DART AEROSPACE LTD	Work Order:	116473
Description: Crosstube Assembly (206L High Fwd)	Part Number:	D206-667-143
Inspection Dwg: D206-667-143 Rev: C		Page 1 of 2

DRAWING NO. D206-667-143
REV. C
SHEET 1 OF 4

TITLE
CROSSTUBE ASSY (206L HIGH FWD) NTS

DRAWING NO. D206-667-143	TITLE CROSSTUBE ASS'Y (206L HIGH FWD)	REV. C	DART AEROSPACE LTD ENGINEERING ORDER		D.E.O. NO. D206-667-143-C-1	SHEET NO. SHEET 1 OF 1	SCALE NTS
DRAWN <i>q</i>	CHECKED <i>ASS</i>	MFG. APPR. <i>[Signature]</i>	APPROVED <i>[Signature]</i>		DE APPR. <i>[Signature]</i>		
DATE 11.07.15	DATE 11.07.20	DATE 11.07.21	DATE 11.07.21		DATE 11.07.21

DETAIL P BONDING STRAP INSTALLATION 2 PL

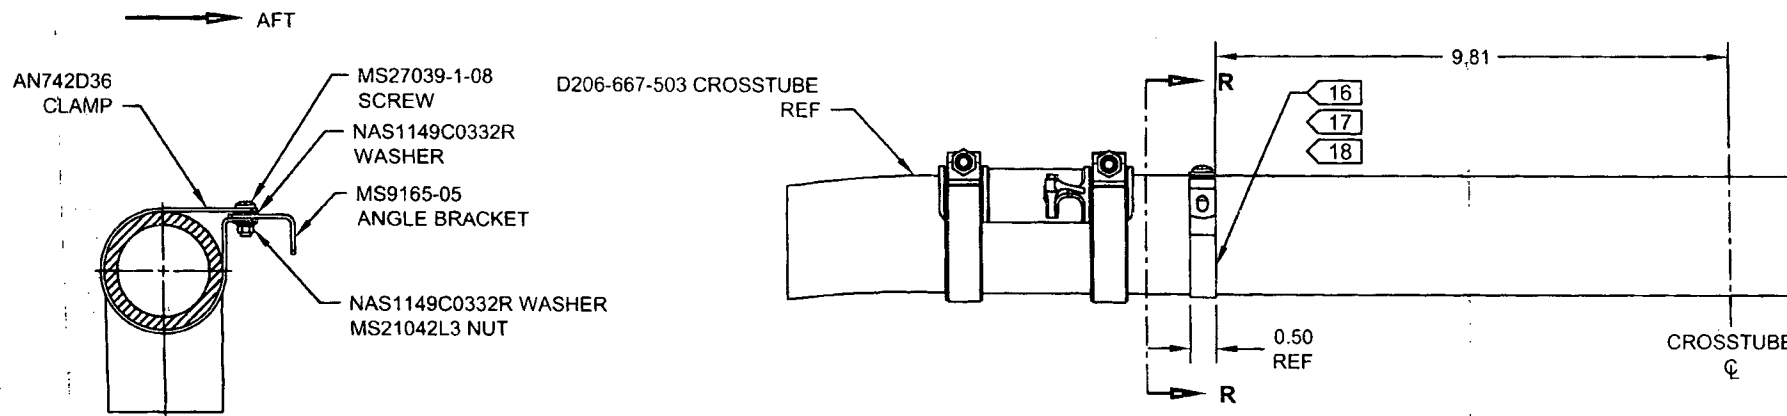
PURPOSE:

ADD ELECTRICAL GROUNDING STRAP

- 16) MASK AREA UNDER CLAMP PRIOR TO PAINTING
- 17) SEAL EDGES WHERE AN742D36 CLAMP MEETS WITH THE CROSSTUBE USING SIKAFLEX-241/-291 OR MIL-S-8802 CLASS B2 OR PROSEAL 890 SEALANT
- 18) PERFORM RESISTANCE CHECK TO ENSURE MAX RESISTANCE IS 10 MILLIOHMS
